RAI 02.04.12-38, Revision 1**QUESTION:**

RAI 02.04.12-39

RAI 02.04.12-40**QUESTION:**

Figure 1: Zone Budget Analysis for Run 301PC.

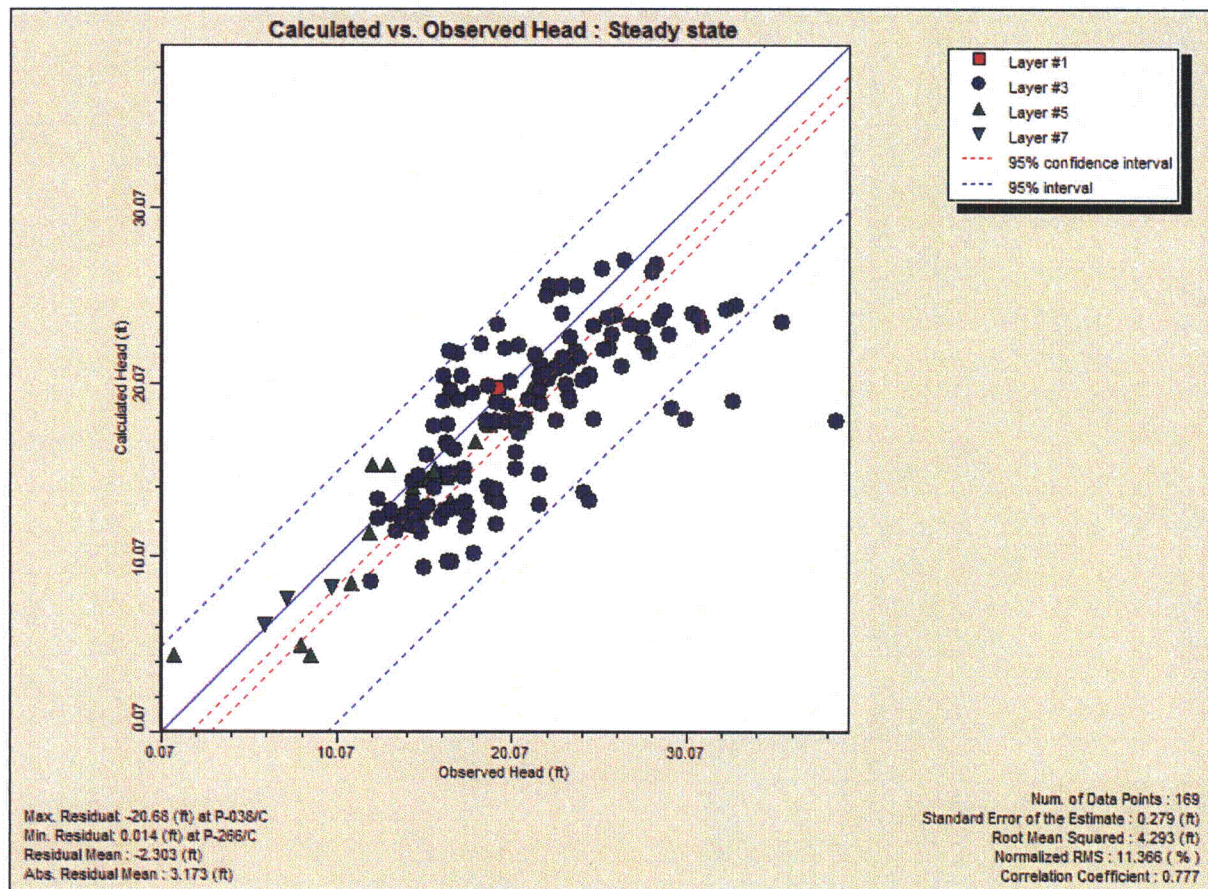
To meet the requirements of 52.79(a) and assist staff in its analysis, additional information concerning the groundwater modeling is required. The calibrated model was used to simulate an MCR surface water level of 49 ft MSL. Provide quantification of the predicted MCR seepage into the groundwater aquifer, and groundwater capture by the system of relief wells and sand drains. For example, provide a water budget for the post-construction simulation of the MCR surface water level at 49 ft MSL similar to that shown for the calibrated model (run 201) in Figure 82. To help evaluate the model as a tool for post-construction predictions, please also discuss whether calibrated model results have been compared against the 47 ft MCR level and the corresponding piezometric heads in FSAR Table 2.4S.12-18.

Figure 1 shows the groundwater budget analysis for post-construction Run 301PC. This figure is similar to the Run 201 pre-construction groundwater budget analysis (Figure 82 of Reference 1). As indicated by a comparison of Figure 82 (Reference 1) and Figure 1, a greater MCR seepage into the groundwater aquifer, and groundwater capture by the system of relief wells and sand drains occurs for this post-construction scenario, as would be expected for the different MCR conditions (Run 301PC).

Figure 1. Potentiometric Surface Map of the Upper Shallow Aquifer, STP Units 1 & 2.

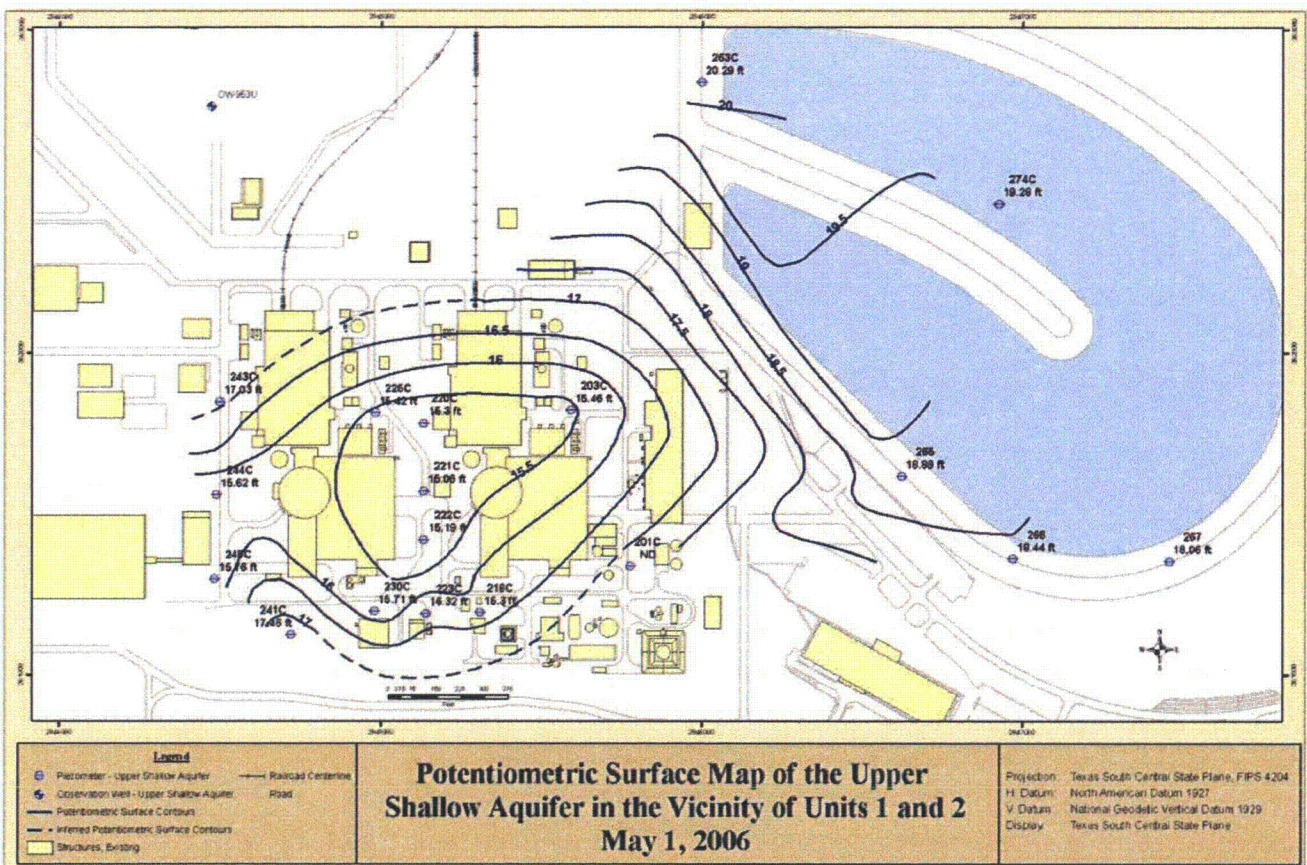
- a. Consistent with the groundwater model results (Figure 71), provide field data from STP Units 1&2 in Stratum C, the Upper Shallow Aquifer, supporting the simulated depression of the water table. Figure 71 would seem to indicate a predicted depression on the order of 4 to 5 ft. Is this depression reflected in observed water levels? If so, provide field data from STP Units 1&2 in Stratum E of the Lower Shallow Aquifer, supporting the simulated mounding of the piezometric surface. Such a mound would be consistent with the groundwater model results of Figures 91 and 100 that indicate 3 to 3.5 ft of mounding at STP Units 3&4 in the future. (See Groundwater Model document, pages 40 and 41 (discussion of Scenarios 1 and 2), and Figures 71, 90, 91, 99 and 100.)

The May 1, 2006 Upper Shallow Aquifer groundwater elevations are depicted on the potentiometric surface map presented in Figure 1. This potentiometric map indicates a depression with a low elevation of 15.06 ft MSL at Piezometer 221C that is centered between STP Units 1 & 2. These elevations increase to an elevation of 20.29 ft MSL at piezometer 263C located at the ECP. Figure 1 suggests a depression of 3 to 5 ft was present in the Upper Shallow Aquifer at STP Units 1 & 2. This configuration is similar to Figure 71 of the Groundwater Model Report (Reference 2), which shows a simulated depression on the order of 4 to 5 ft with the lowest contoured level at 15.0 ft MSL. Similarly, the May 1, 2006 data for the Lower Shallow Aquifer were used to prepare the potentiometric surface map in Figure 2. This

Figures 1 and 2 illustrate the measured May 2006 groundwater levels as contoured groundwater elevations for the Upper Shallow Aquifer and the Lower Shallow Aquifer at STP Units 1 & 2. Figure 1 supports the model simulation of the depression in the Upper Shallow Aquifer as illustrated by Figure 71 of Reference 2. Additionally, the mounding in the Lower Shallow Aquifer predicted by the model (Figure 73 of Reference 2) is supported by the May 2006 data as shown in Figure 2. Conceptually, the depression and mounding features are a result of the equilibration of the vertical head differential between the Upper Shallow Aquifer and the Lower Shallow Aquifer through the permeable backfill that connect Strata A through E. The consistency between the measured piezometer data and the model simulations of the Upper and the Lower Shallow Aquifers indicates that the model represents the physical hydrogeologic conditions at STP Units 1 & 2 and can be used for predicting post-construction scenarios at STP Units 3 & 4.
